CERTIFICATE OF APPROPRIATENESS

Applicant: Sanobar Bhaidani, owner
Property: 815 Harold Street, Lot 4, Block 22, Montrose Neighborhood Subdivision.
The property includes a historic 3,834 square foot, two-story wood frame single-family residence and a detached garage situated on a 6,000 square foot (50' x 120') interior lot.

Proposal: Alteration: Reconstruction of Rear Addition, Front Door, and Windows
Tagged for work w/out permits: 11/16/22; 11/30/22; 12/05/22;1/17/23; 2/7/23

**CURRENT PHOTO – Provided by Applicant**

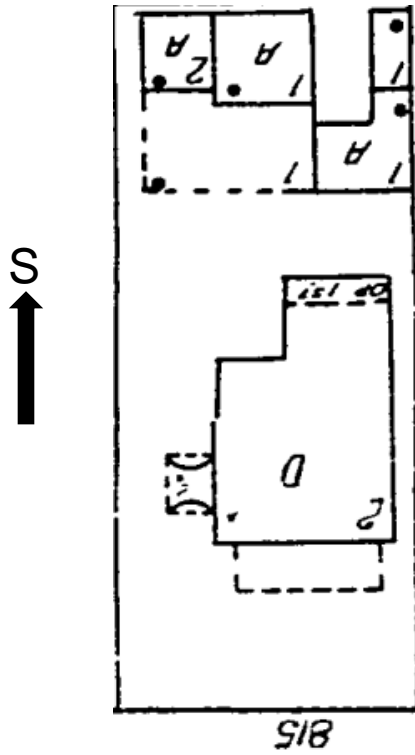
Proposal is to remove four window openings and replace with siding on the left elevation

**Proposed Front Elevation (Rear Addition Not Visible)**

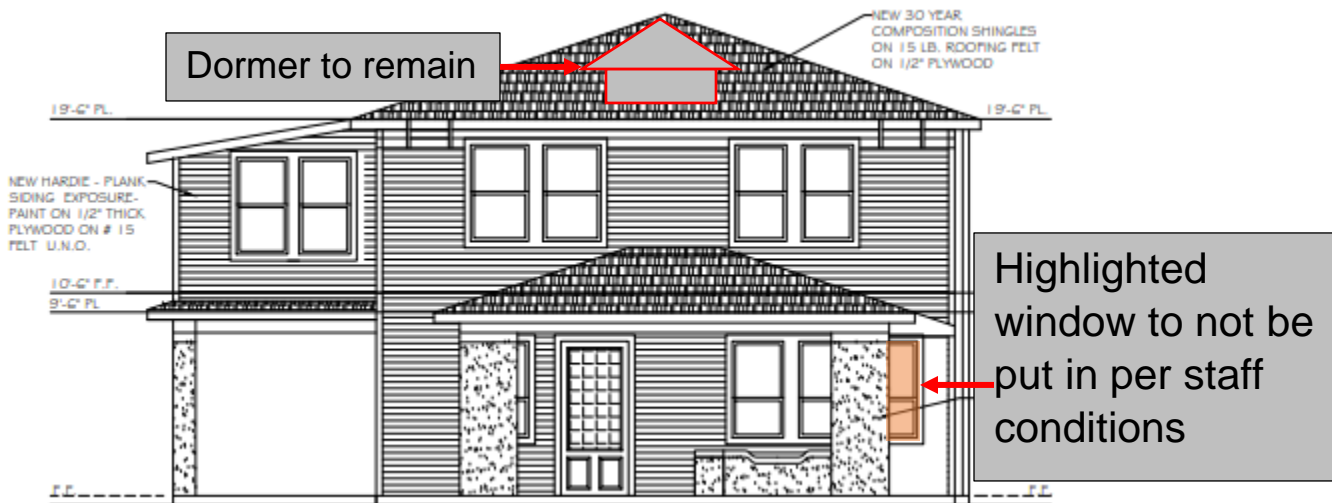
All original windows and front door to remain

Existing Rear Elevation

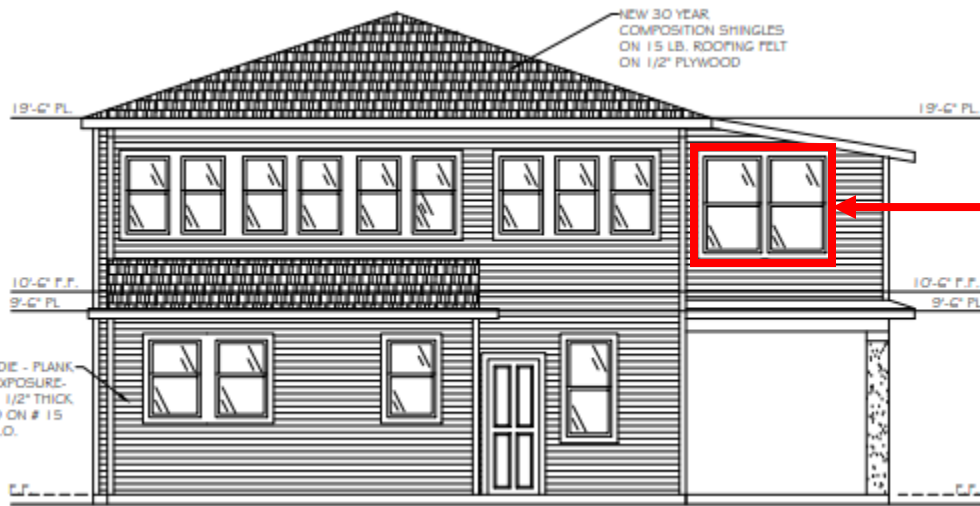
Smooth, cementitious siding on rear addition with a 5" lap reveal

Only one window opening exists as seen in photos

Existing Right Elevation

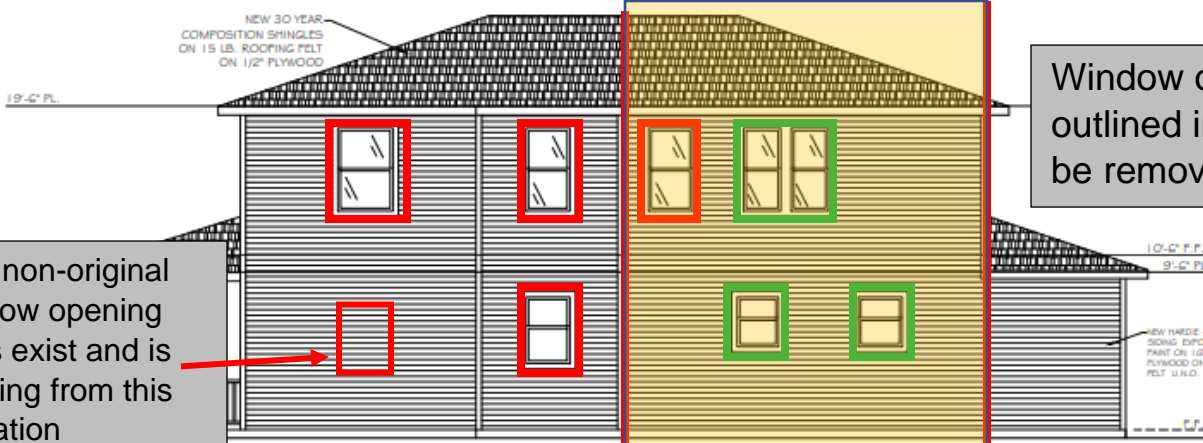
Window openings outlined in green to be removed

This non-original window opening does exist and is missing from this elevation

Proposed Right Elevation

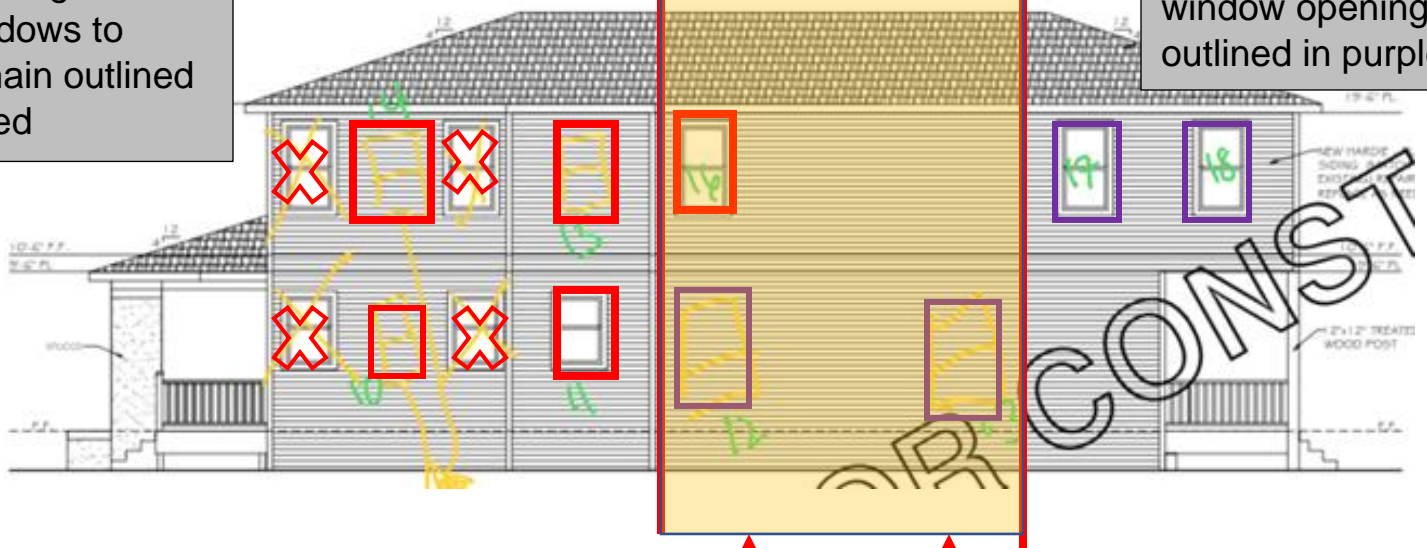
Proposed window openings outlined in purple

Existing windows to remain outlined in red
